**North Liberty Planning Commission
Tuesday, April 5, 2022, 6:30 PM
North Liberty City Council Chambers
1 Quail Creek Circle, North Liberty, Iowa 52317**

To **City of North Liberty Planning Commission**
From **Ryan Rusnak, AICP**
Date **April 1, 2022**
Re **Request of the City of North Liberty to amend the Comprehensive Plan Future Land Use Map on 25.64 acres, more or less, on property located on the east side of North Dubuque Street approximately 185' south of Scales Bend Road from Commercial and Industrial to Residential.**

To **City of North Liberty Planning Commission**
From **Ryan Rusnak, AICP**
Date **April 1, 2022**
Re **Request of Archie's Rent A Ride, LLC to approve a Site Plan for a minor vehicle repair facility and related site improvements on approximately 1.5 acres of property located at 1040 Liberty Way.**

Non-binding concept plan with the townhome portion of the development circled in red.

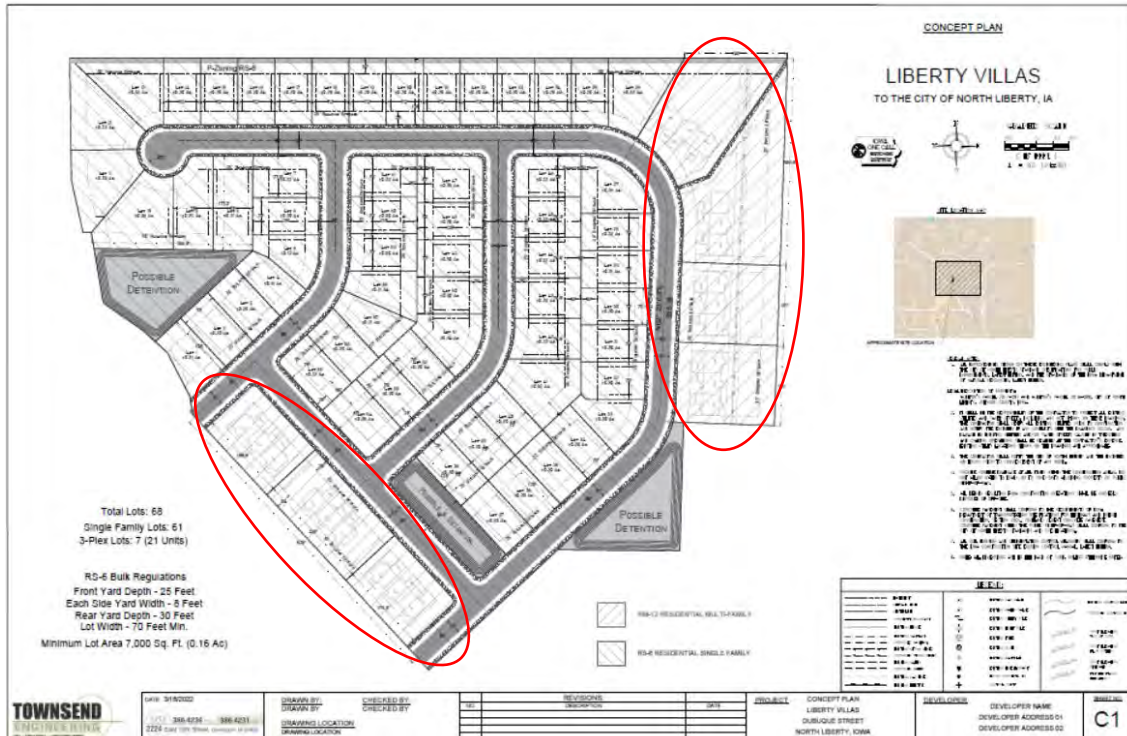
The flexibility being sought is allow the townhomes within the multi-family portion of the development to construct individual curb cuts along a public street. This is not permitted in the Off-Street Parking Ordinance, as typically, there would be a townhome development double loaded on a private street with only the private street having direct access to the public street.

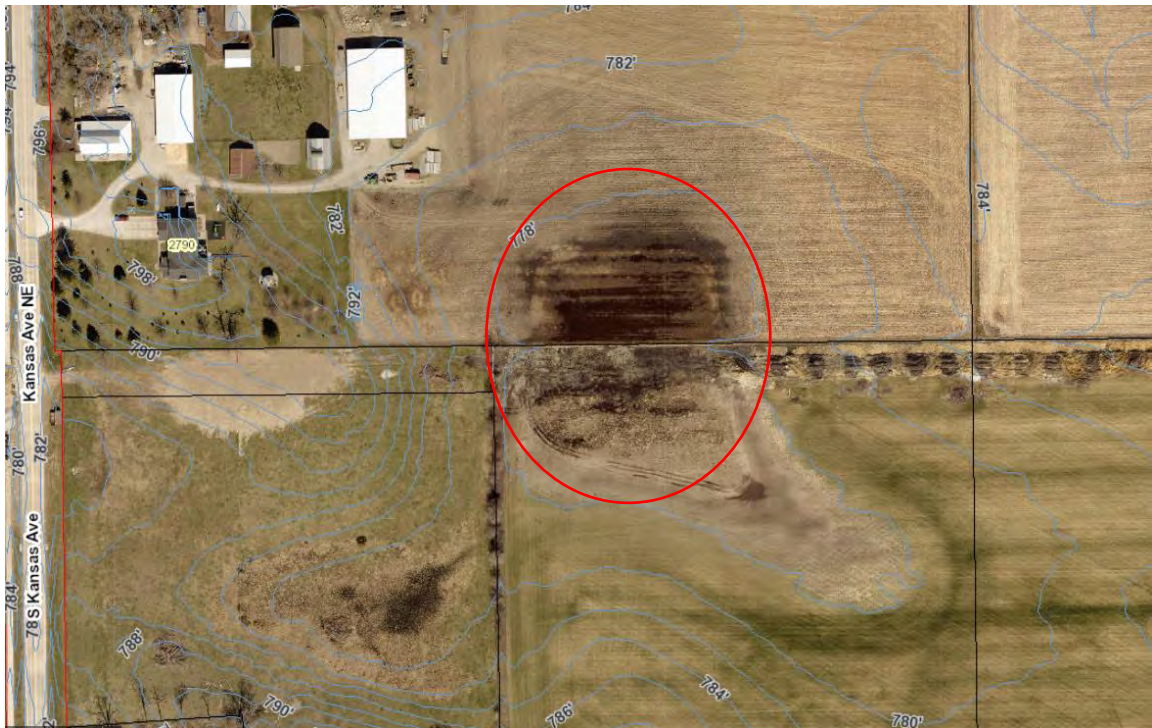
The adjacent property owners to the north expressed an important concern regarding drainage. There is a low spot between the two properties, which does not have an immediate outfall. Please see discussion regarding this concern in the approval standards section.

The other concern expressed by the property owners to the north was maintenance of the fence along the common property line. It is staff's opinion that the 10' landscape easement (and the sanitary sewer force main easement) should be unobstructed by homeowner fences and that the homeowners' association should be given free access
